RGA No. 22008
March 2, 2023

ADDENDUM NO. 1

**LAKE FOREST SCHOOL DISTRICT -
Delaware Early Childhood Center – HVAC Upgrades**
100 W. Mispillion St., Harrington, DE 19952

SK-01

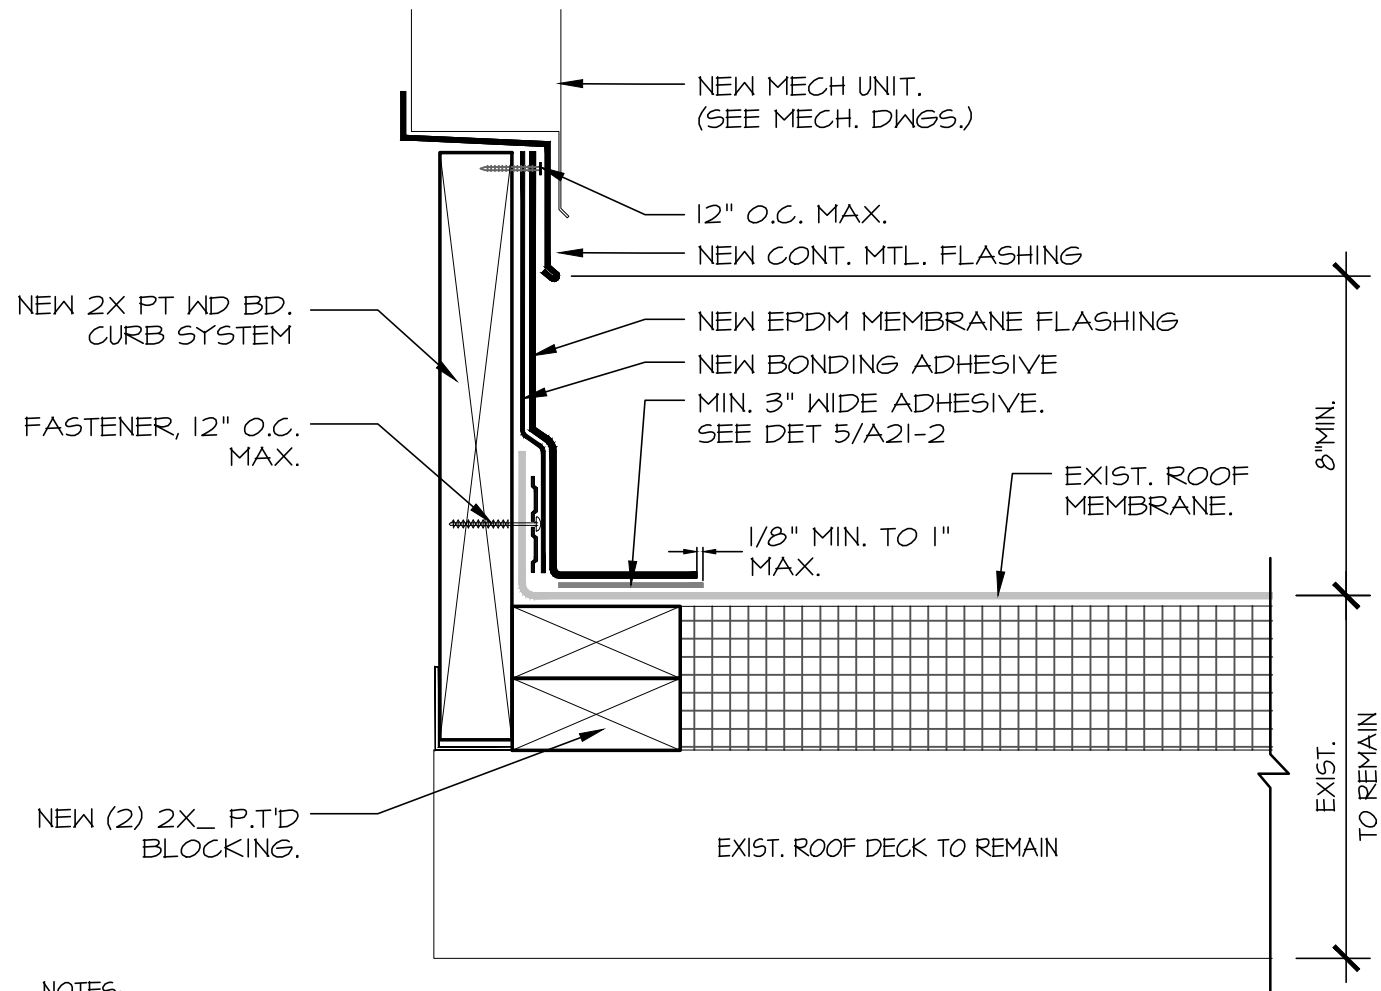
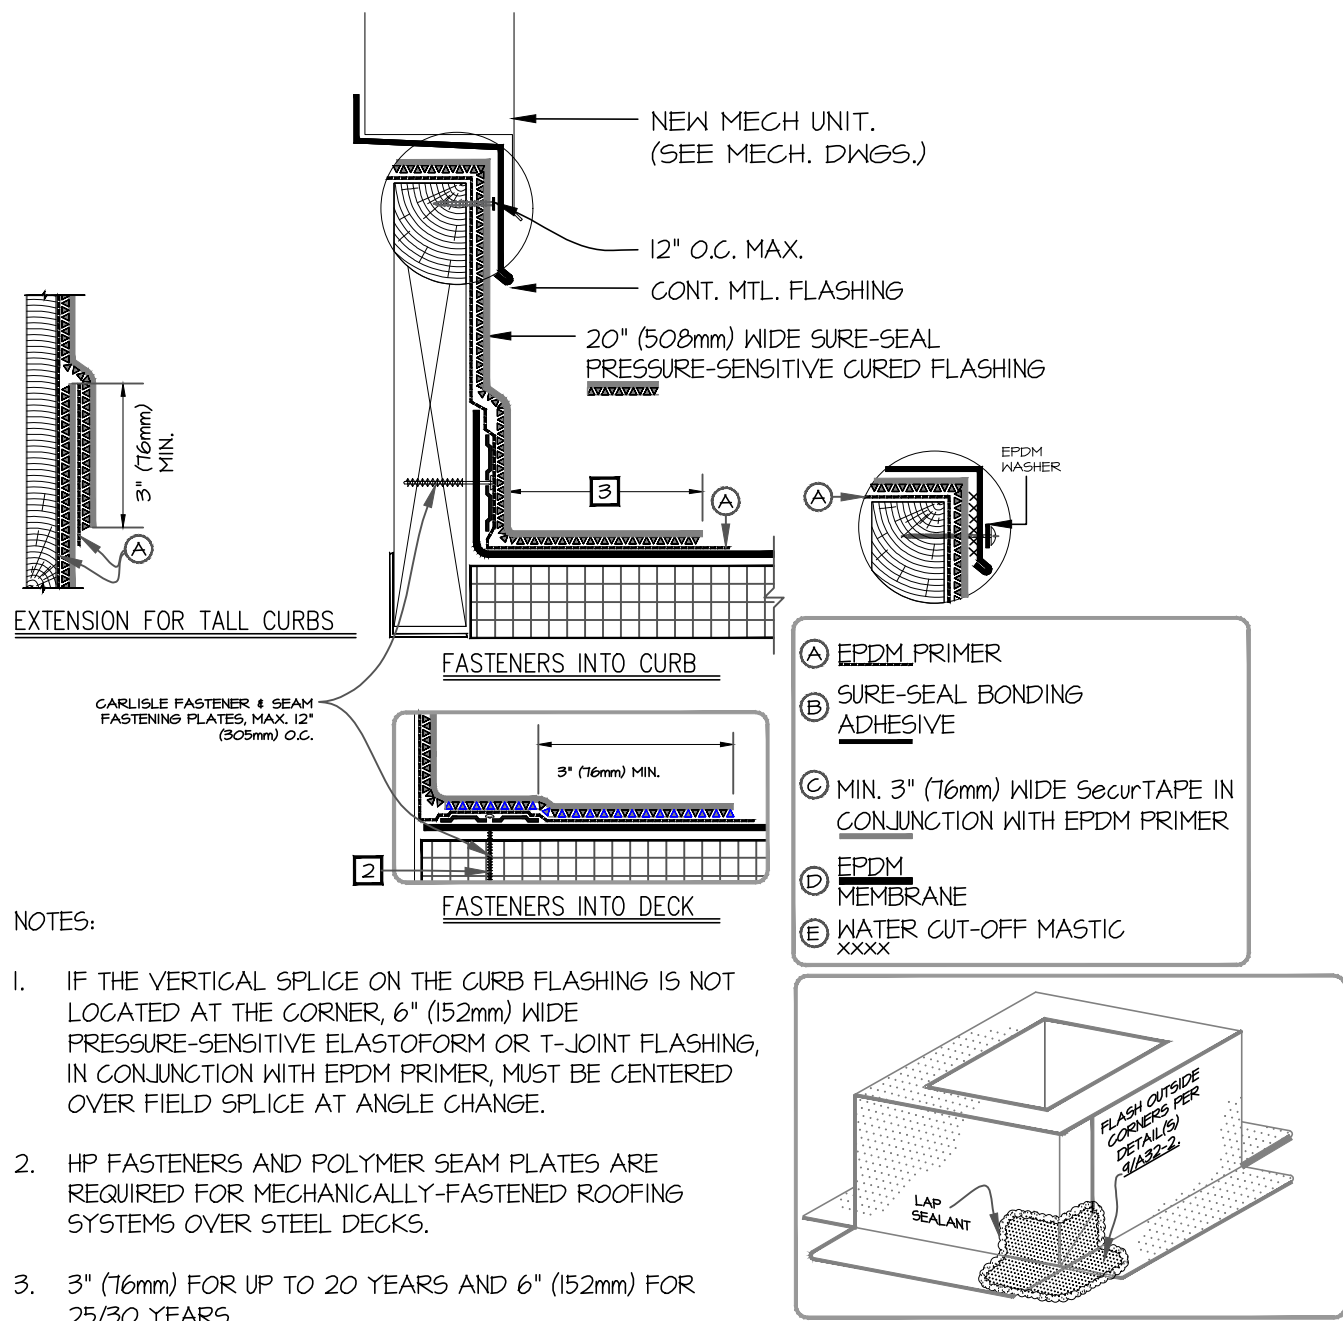
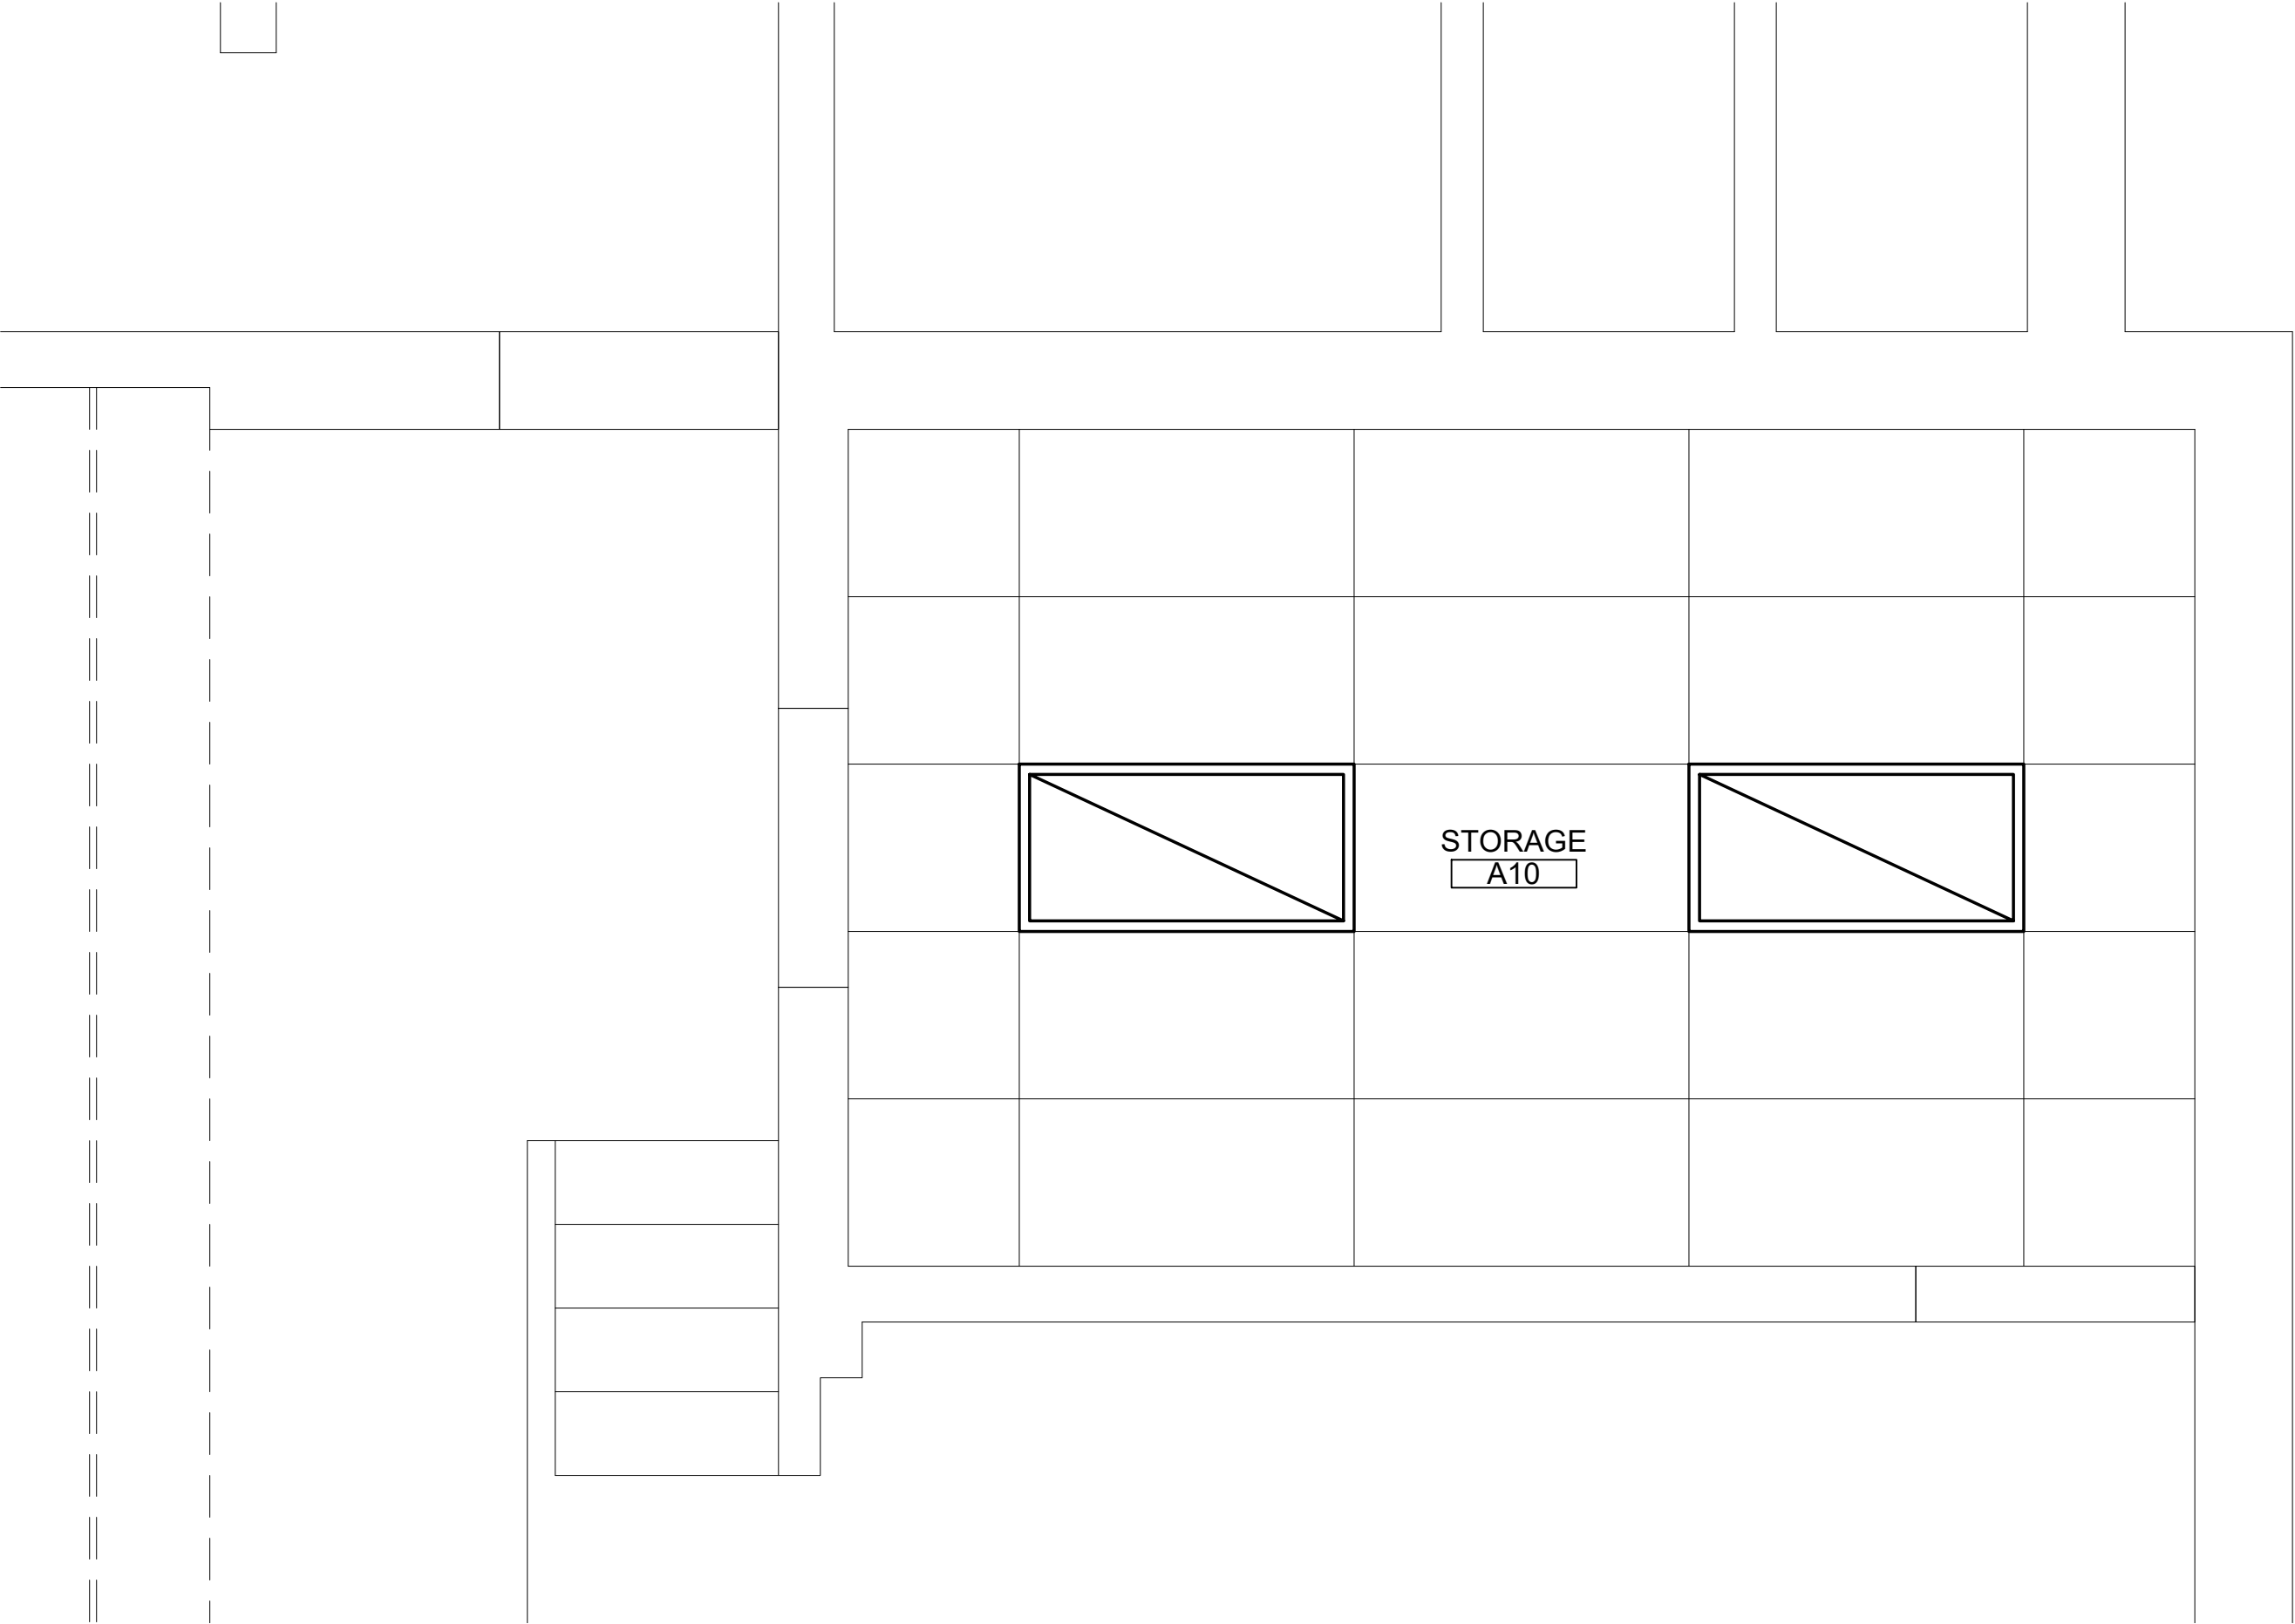
Q8 – What is the existing roof type that we are to be tying into?

Answer: See the attached sketch SK-01, dated 14_March 2023 for roof curb details.

ED-1

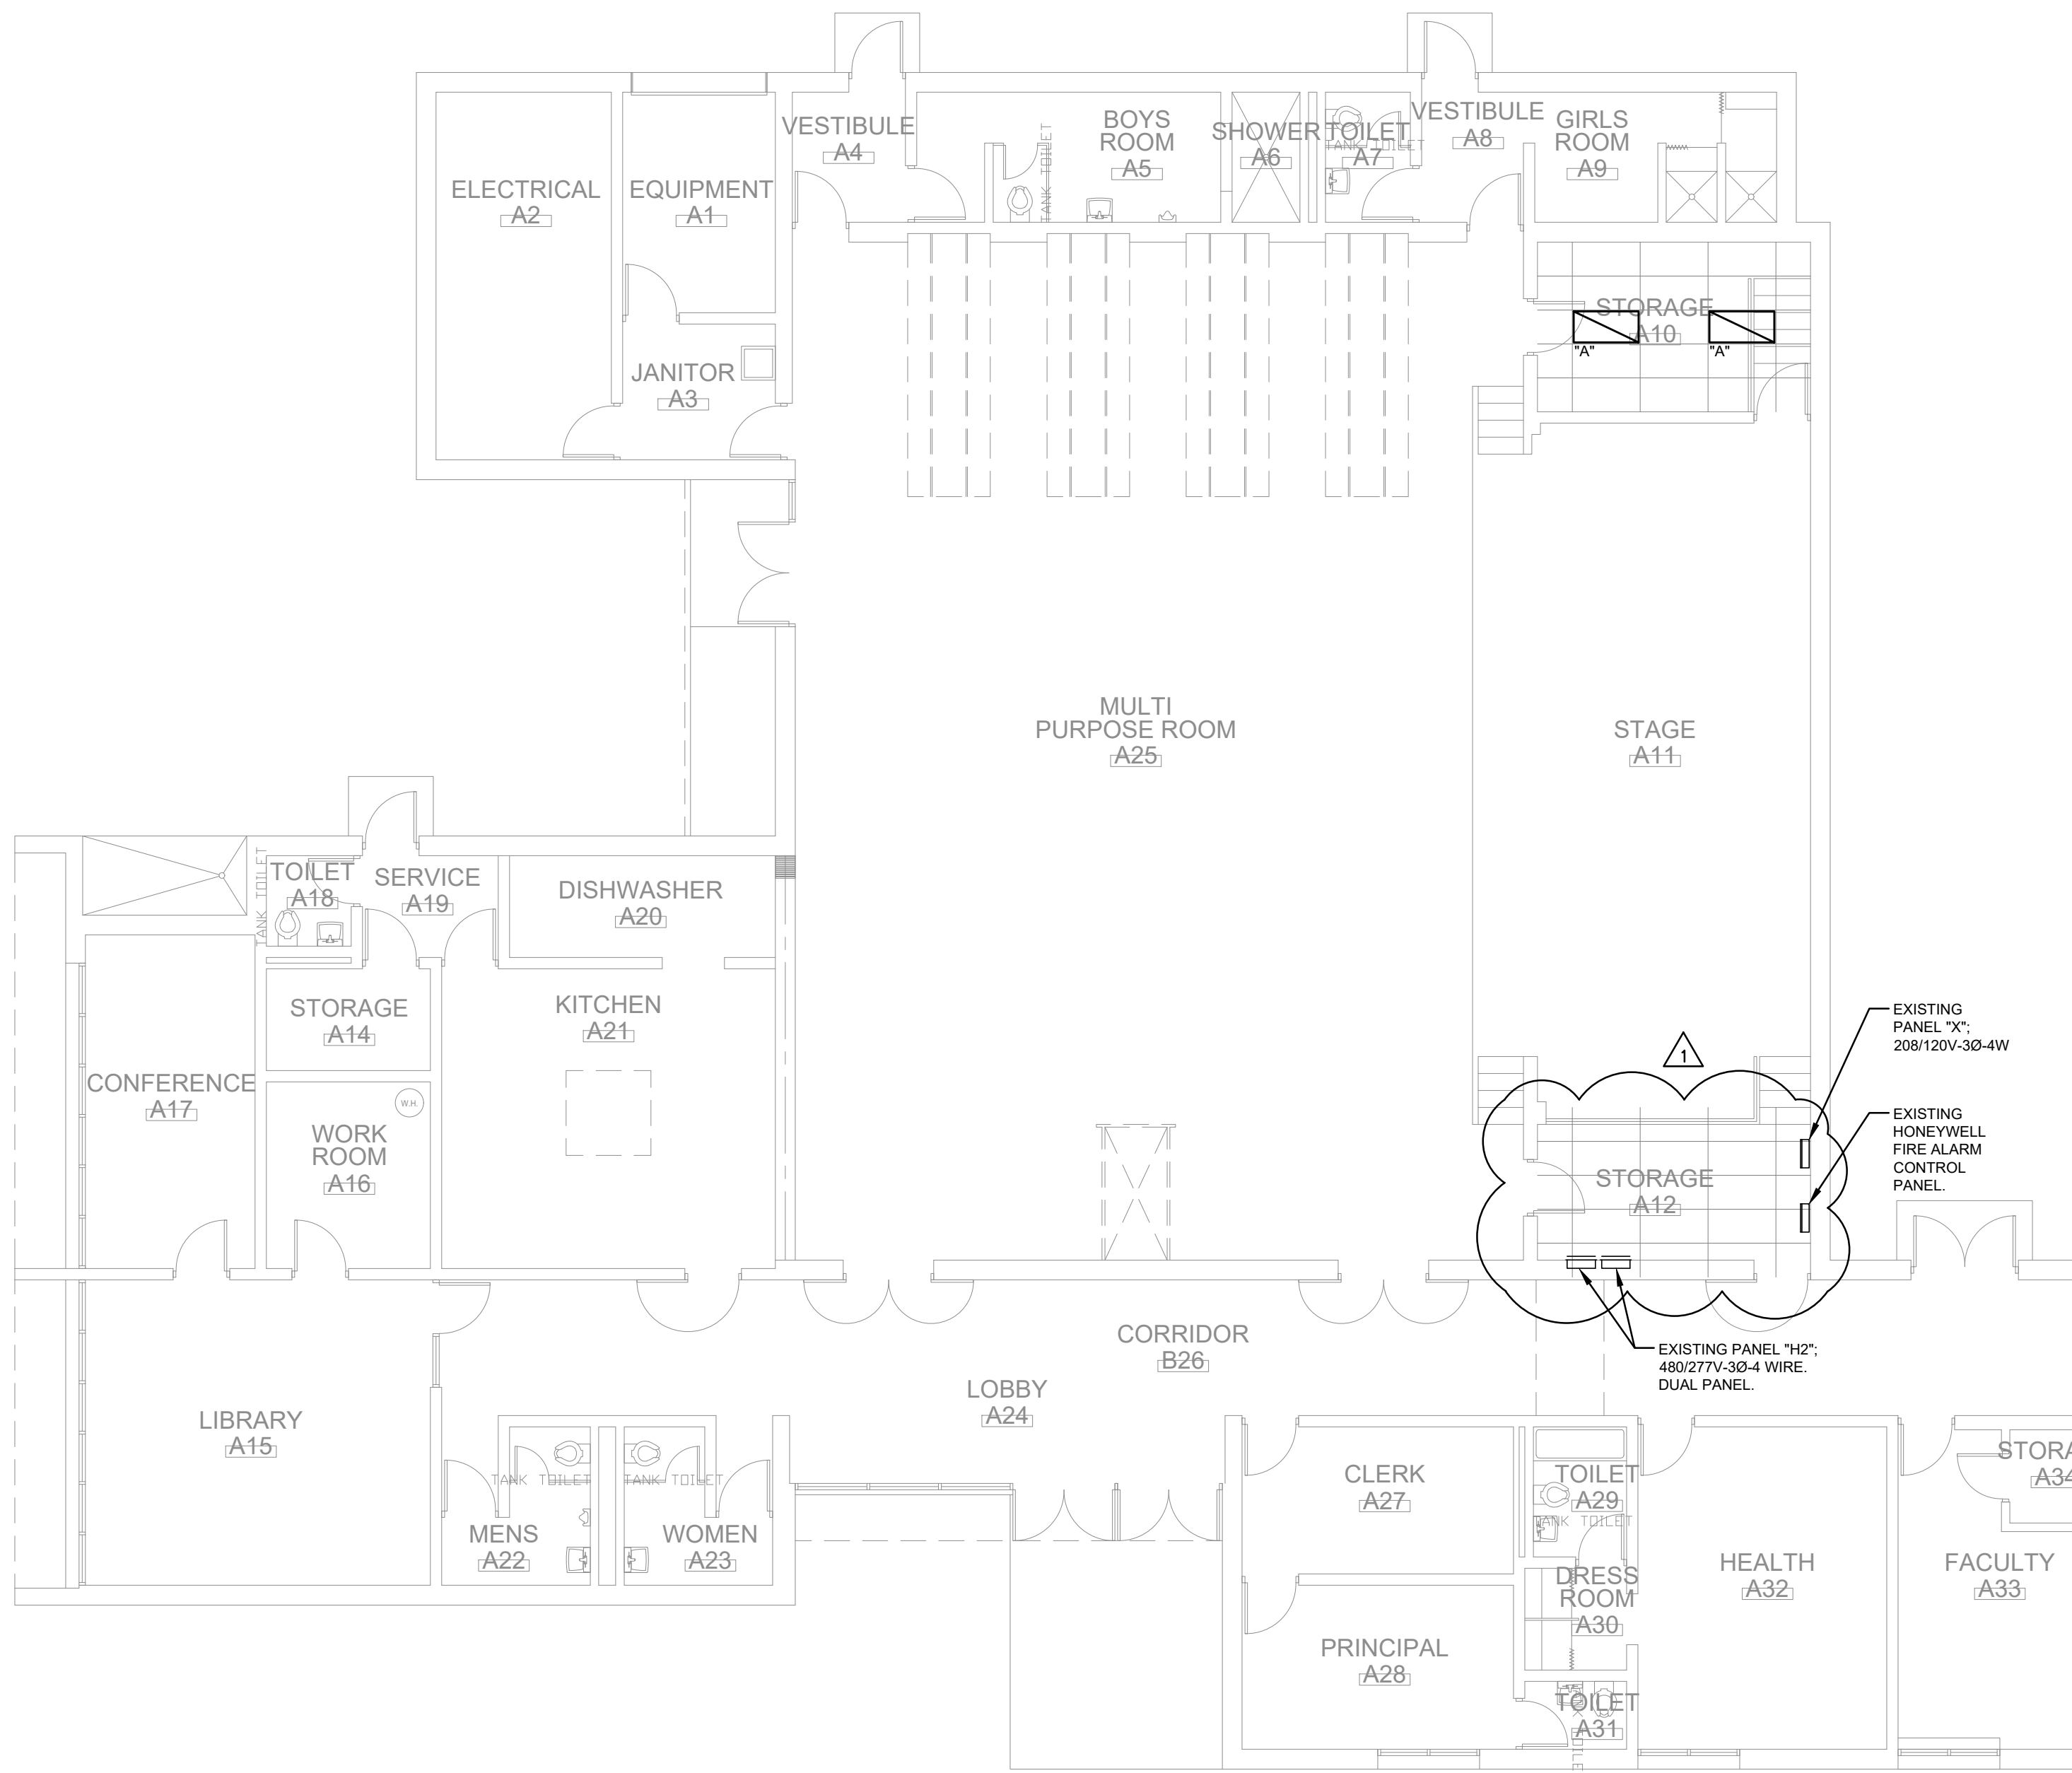
- 4.1 Drawing ED-1, “FLOOR PLANS DEMOLITION ELECTRICAL”
4.1.1 REMOVE Existing lighting shown in room A12. See revised drawing ED-1.
4.2 Drawing E10-1, “FLOOR PLANS NEW WORK ELECTRICAL”
4.2.1 REMOVE New lighting shown in room A12. See revised drawing E10-1.
